Meeting Date: November 12, 2024 **Time:** 9:00 AM

Subject: Highway Occupancy Permit Application No. 320663, Cycle No. 4

The following PennDOT Cycle 4 comments were discussed at the HOP Collaboration Meeting:

Modified WB-62

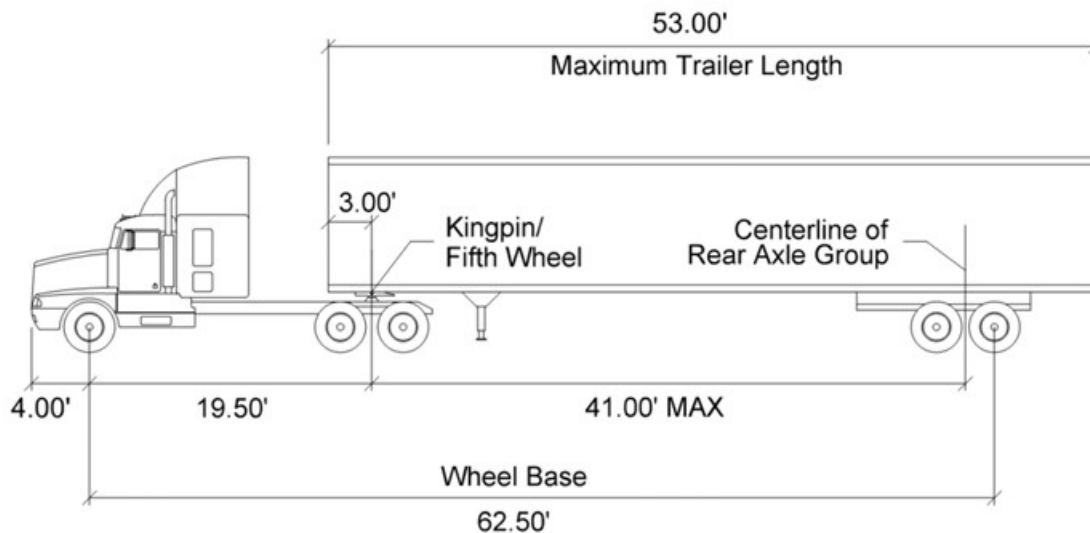
1. *Revise the truck turning templates to utilize a WB-67 design vehicle*

Below is an excerpt from our plans showing the semitrailer that we utilize for truck turns. It is a modified WB-62 with the same trailer length as a WB-67. See below documentation from PA Code and additional explanation. KCI uses this design vehicle on all HOP projects in PA at this point that involve semitrailers up to the legal maximum, including warehouse developments. We have used this on recent HOP projects in Districts 4-0, 6-0, 8-0 and 12-0. Most Districts seem to require this now as the max design vehicle for a HOP.

Please confirm that we are OK to keep our modified "WB-62 PA" as the design vehicle, or if District 5-0 is requiring that we design for a non-street legal vehicle (WB-67). Our design vehicle uses the same trailer length (53') as the WB-67 (the original WB-62 has a 48' trailer).

i.e., the trailer is **53 feet**, but the distance between the kingpin and centerline of the rear may not exceed **41 feet**. Below is the modified WB-62 PA that KCI uses for all semitrailer turning movement design. This is the largest legal semitrailer in Pennsylvania. A WB-67 would have a distance between kingpin and centerline of rear axles of 45.5' and is not street legal in PA.

Resolution: PennDOT/Dimmerling confirmed that KCI's approach – utilizing the maximum PA-legal semitrailer (WB-62 with the same 53' trailer length as a WB-67) is acceptable. See attached email for additional information.
